THOR
INDUSTRIES, INC.

07V-281
(11 Pages)

Re: Thor California
Defect and Non-Compliance Report

Fresh Water Tank Weight Offset

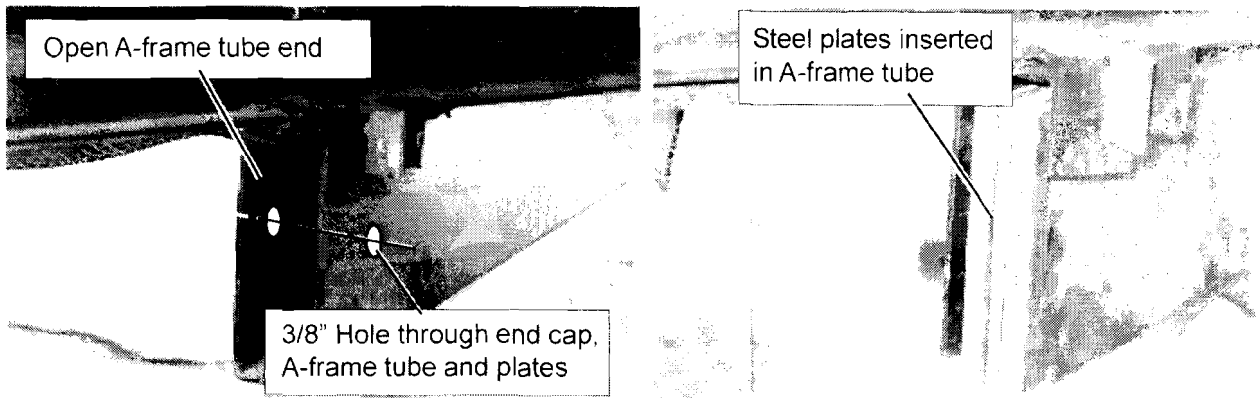
1. Detach the lower edge of the skirt material to the front wall, and back far enough to allow the entry step to be removed without damaging the skirt material. Remove the front entry step, as shown below.

Remove the entry step attaching hardware, and lower the step with the floor jack. Set aside the hardware for reinstallation.

End cap installed (bench unit shown). The end cap included in the parts kit may vary from the one shown, but installation is the same.

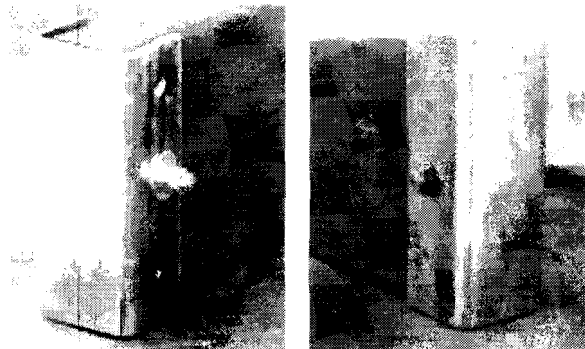
3. Install the A-frame end cap and clamp in place. With the 3/16" drill bit, center and drill a pilot hole through the end cap and into the A-frame. Follow with 3/8" carbide-tipped drill bit. Insert 3/8" bolt through A-frame tube and plates, attach and tighten nut. To secure the forward end of the plates, drill another hole in the forward end of the A-frame tube 6" - 8" forward of the front crossmember, insert bolt, attach and tighten nut.

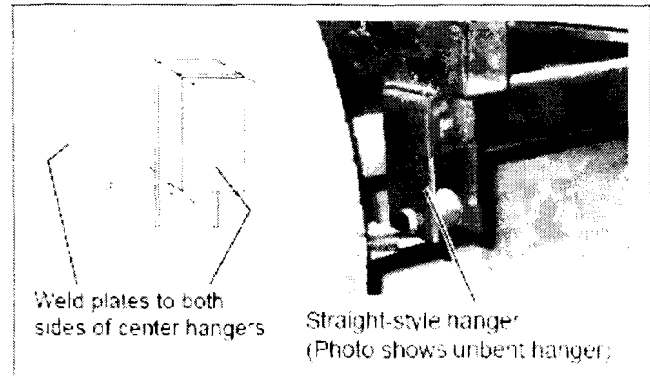
3. Straighten axle hangers as necessary. Reinforce the front and rear hangers by welding a 2-3/4" X 4" X 1/4" steel plate to the the side of the hanger away from the axle. The plate should overlap the outside of the hanger by approximately 1/8" on each side. Reinforce the center hangers by welding 2-3/4" X 4" X 1/4" steel plates to both sides of the hangers.

Weld reinforcing plate to this side only on front and rear hangers
